Pentagon Knit Com Ltd. Global Apparel Park Ltd.

17th January, 2017

Observations

Column schedule

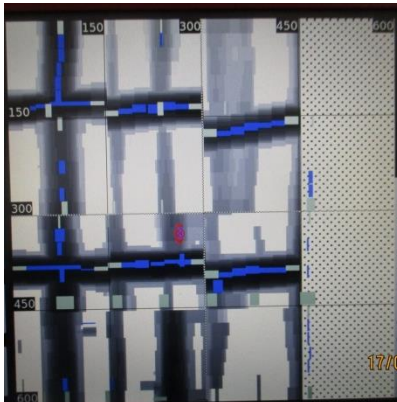
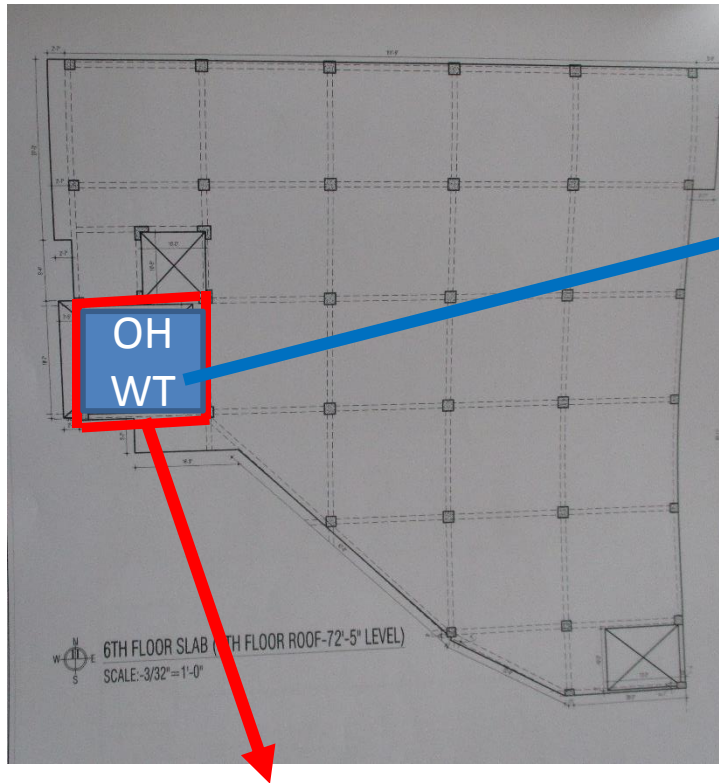
The number of reinforcement does not match with column schedule . 16 number of rebar was found where column schedule shown 20 rebar. Factory engineer is required to be checked and update as built drawing.

Utility Building

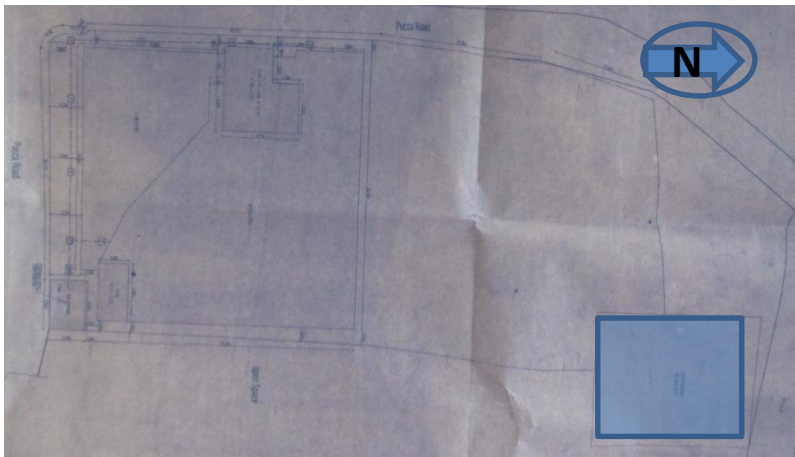
No detail drawing (As-built structural) was available during inspection.

Item No.	Observation	Recommended Action Plan	Recommended Timeline
1	As- Built Structural Drawing of Utility Building was not available	Building Engineer to produce a set of As Built drawing Utility building.	6-weeks
2	Adequacy of slab under OHWT needs to be checked	Building engineer to review that slab under OHWT is designed to carry the imposed load .	6-weeks
3	Adequacy of slab under OHWT needs to be checked	Implement any actions arising from review.	6-months
4	Exposed and corroded rebar	If further construction is intended, factory engineer to verify if the rebar's are in good condition and replace them if necessary.	6-weeks
5	As- Built Structural Drawing of Utility Building was not available	Building Engineer to produce a set of As Built drawing Utility building.	6-weeks
